ADDENDUM NO.2

**CHICAGO O'HARE INTERNATIONAL AIRPORT
TERMINAL 5 CONCOURSE M EXTENSION SITE/CIVIL PACKAGE
SPECIFICATION NO. 766477**

SHEET NO.	REVISION
T-205	1

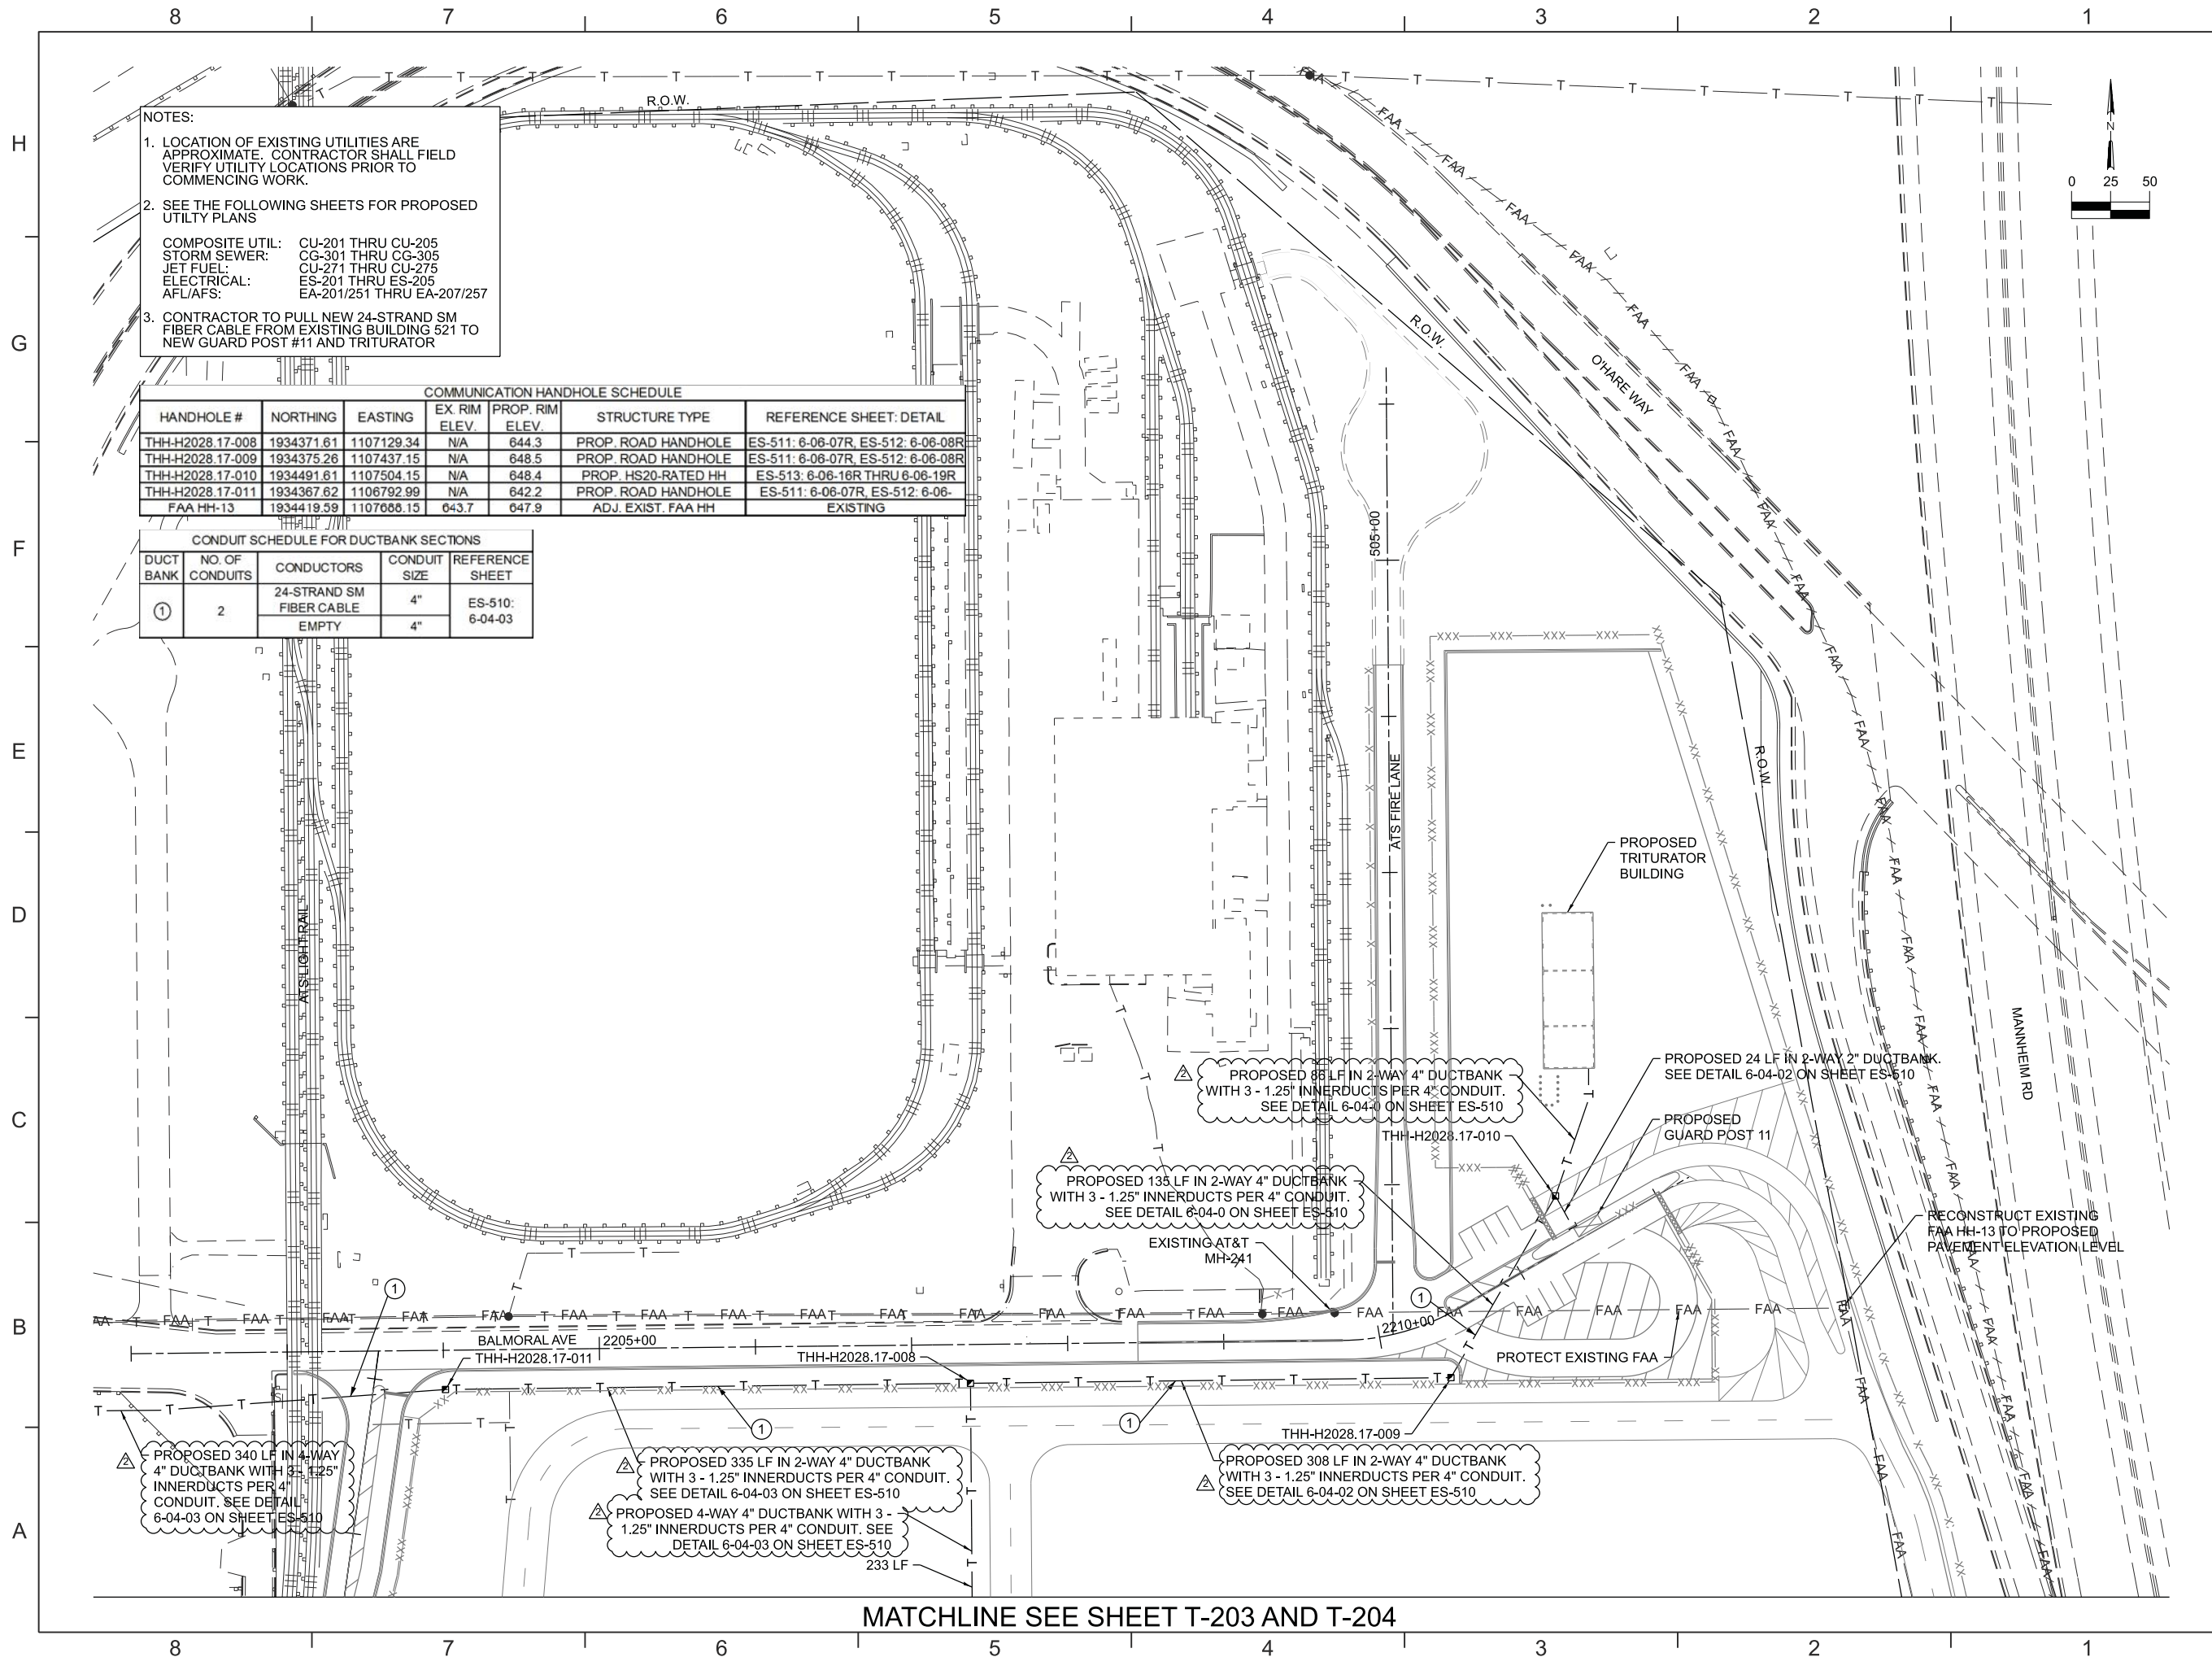
T-202	Modified call out to indicate required innerduct.
T-203	Modified call out to indicate required innerduct.
T-204	Modified call out to indicate required innerduct.
T-205	Modified call out to indicate required innerduct.

Response:	<i>Bullet resistance not required, storm resistance is required (wind loading). Use tinted glass.</i>
Question 24:	Item 148, L-110-10 Innerduct, 1.25" - Where is this innerduct installed?

Response:	<i>Three 1.25" innerducts are required to be installed within each 4" PVC conduit in all Telecommunications Duct Bank shown on Drawing Sheets T-201 to T-205. Callouts on Drawing Sheets T-201 through T-205 will be modified to indicate required innerduct.</i>
